Meeting name	Supplier Volume Allocation Group
Date of meeting	04 August 2009
Paper title	Change Proposal Progression
Purpose of paper	For Decision
Synopsis	This paper provides: <ul style="list-style-type: none">• 8 Change Proposals (CPs) for decision;• an update on the Gross Volume Correction (GVC) Draft Change Proposals (DCPs); and• details of the status of all Open Draft Change Proposals (DCPs) and Change Proposals (CPs).

- **AGREE** our suggested amendments to the redline text for CP1267 version 1.0 (shown in table 3 of Appendix 1).
- 2.2 CP1288 – Revisions to Meter test points within Code of Practice 4

Figure 1: Example showing Type A Calibration Points for a CoP1 and 2 Reactive Energy Meter

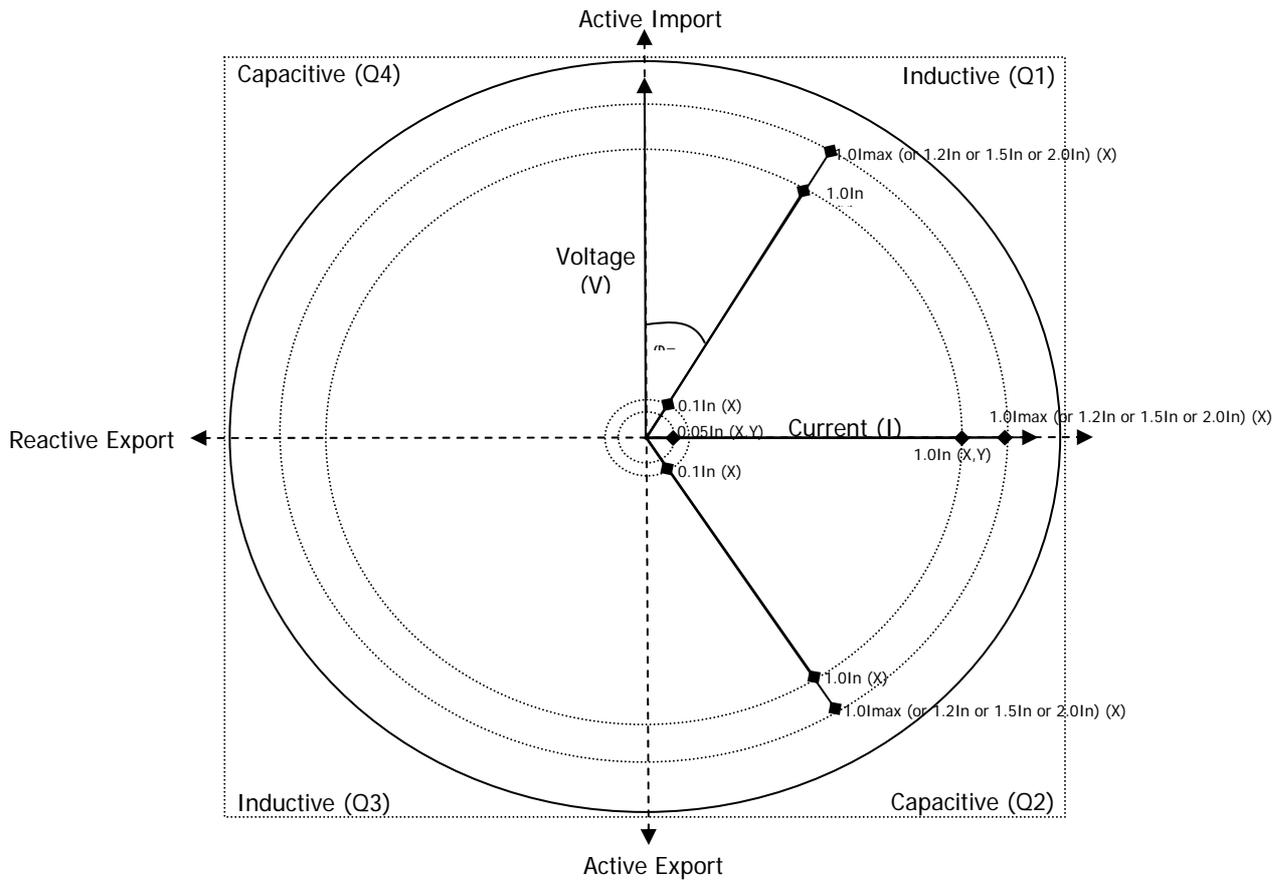
Inserting of a new diagram (Figure 1) into Appendix B to clarify the test point requirements for CoP 1 and 2 Reactive Meters

- 4.4 Additionally, a respondent suggested that the vector diagram in the British Standard 'BS EN 62053-23' is used within CoP4. We recommend that the SVG agree that the vector diagram contained in Appendix C of BS EN 6253-23 should replace the vector diagram that was issued during the impact assessment of CP1288.

No	Organisation	Document name	Location	Severity Code ¹⁰	Comments	ELEXON Recommendation
1	Cewe Instrument AB	CoP4	App 1 table B1 vector diagram	H	Internationally recognised standard diagram to be used.	As detailed in our response to Cewe in the table above, ELEXON recommends that the vector diagram from BS EN 6253-23 is used in place of the diagram issued for impact assessment.
2	Cewe Instrument AB	CoP4	App 1 Table B1	M	Are single phase load points required for 3ph 3wire networks?	Please see our response to Cewe in the table above. We also confirmed with the respondent that no changes will be required to the redline text.
3	British Energy	CoP4	Tables B1, B2, B3, B4, B5	M	For consistency with proposed changes to the headings for Reactive Meters and Active meters on Table C1(a), and with existing headings on Tables C1 & C2, it is suggested the headings for Active meters be amended to include reference to "(Cos Ø)"	Comment noted. ELEXON recommend that the SVG agree that amendment is made, as it adds further clarity to the proposed redline text. Therefore all remaining references to 'System power factor' in tables B1 to B5 should be replaced with Cos Ø.
